Addendum No. 1

Project: North Carolina State University
Textiles Complex
Flex Factory Renovations
Raleigh, NC 27607

ADDENDUM 01

Project: NCSU – Textiles Complex – Flex Factory Renovations
SCO ID#: 23-26253-01A
NCSU Project ID: 202220031
Date: June 16, 2025

E200

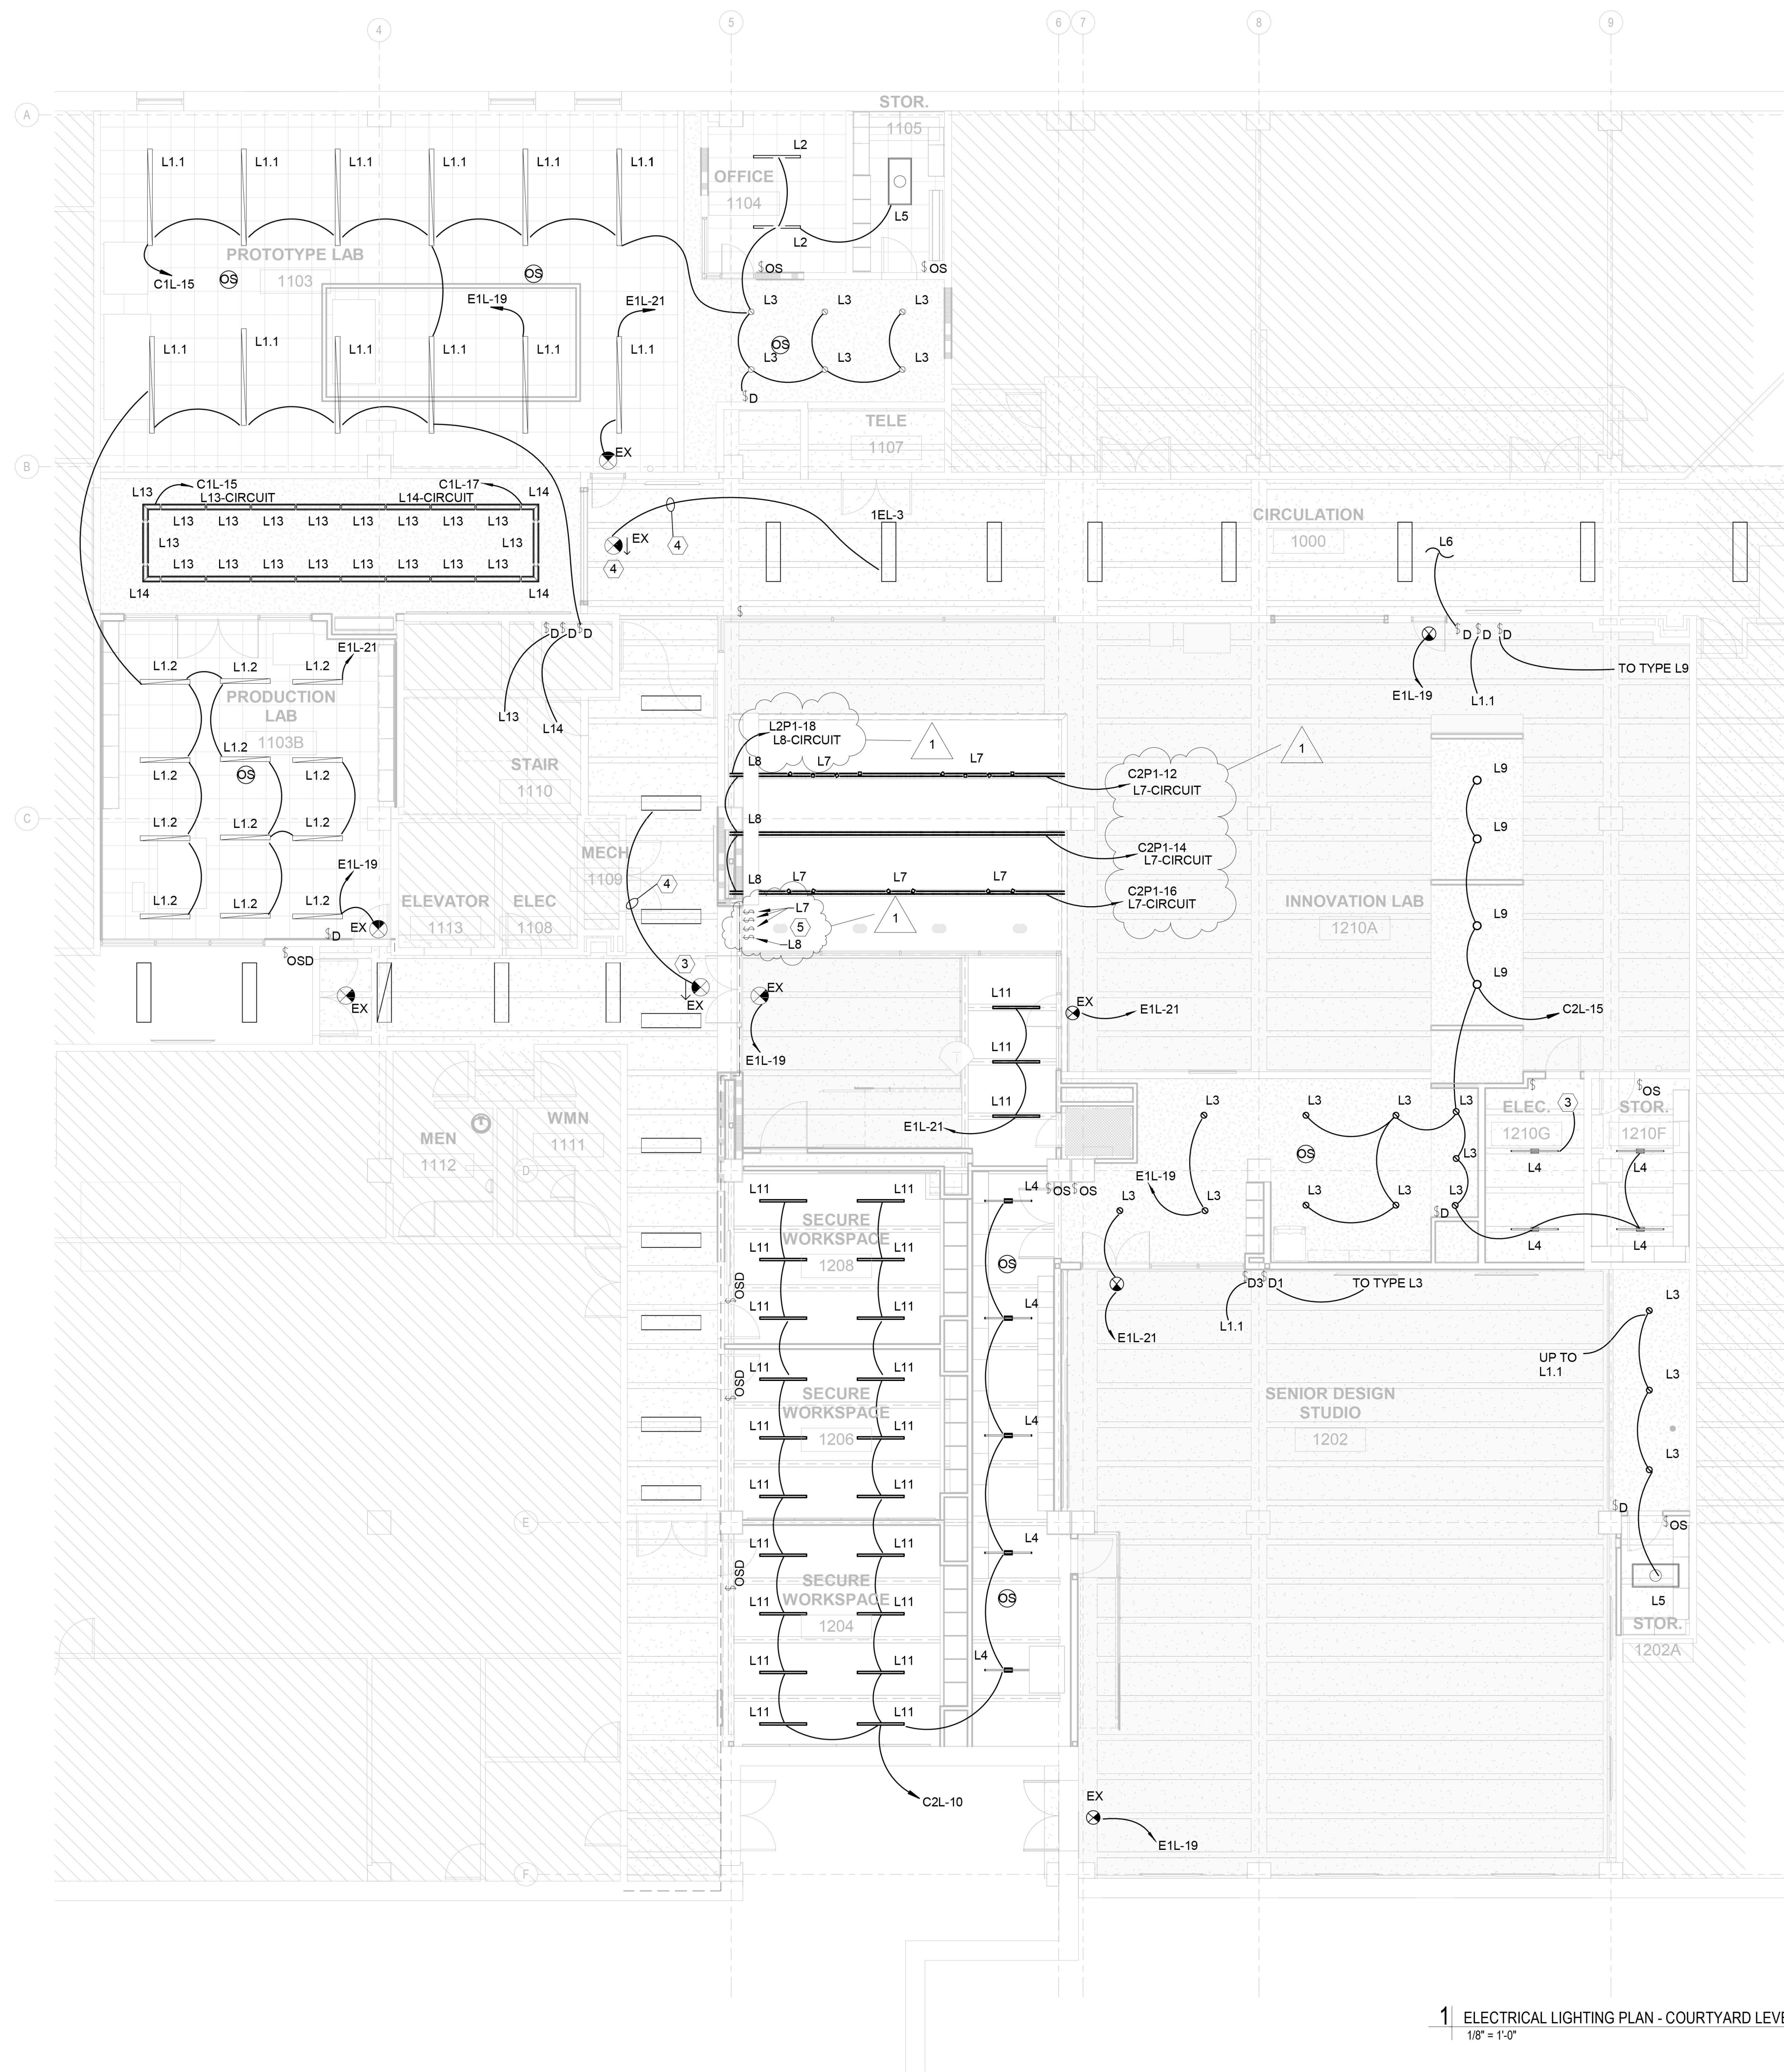
- RFI No. 043 *Referencing drawing E200. What controls light fixtures type L7 & L8, on/off?*
Response: Refer to the revised sheet E200 issued in this addendum for the switch location.

Response: Fixture L8 should be provided on both sides of the I-Beam as detailed in drawing 2/A111.
- RFI No. 045 *See picture attached. There is no panel C26. How should we feed the L8 fixtures.*

Response: Refer to the revised sheet E200 issued in this addendum.
- RFI No. 046 *See panel schedule attached. We cannot locate the highlighted circuits on the drawings.*

SHEET NO.
E600

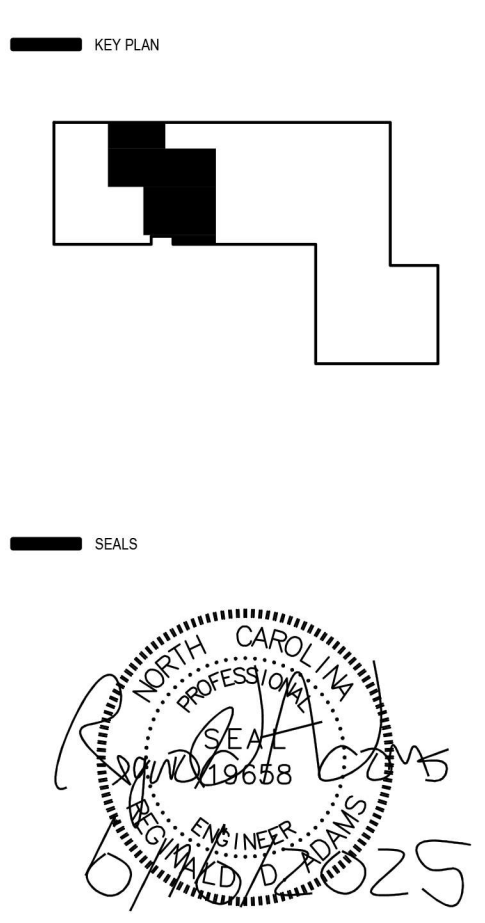
Response: The restaining of existing concrete in Alternate No. 2 is furnished and installed by the BP09G Paintings / Coatings contractor.
- RFI No. 037 *We have E600 Point by point lighting page which doesn't match E200 courtyard lighting plan. Are we missing an alternate page or is E600 not accurate.*

Response: Refer to the revised sheet E600 issued in this addendum.
- RFI No. 038 *Do we have enough parking for our team, or do we need to consider parking passes?*
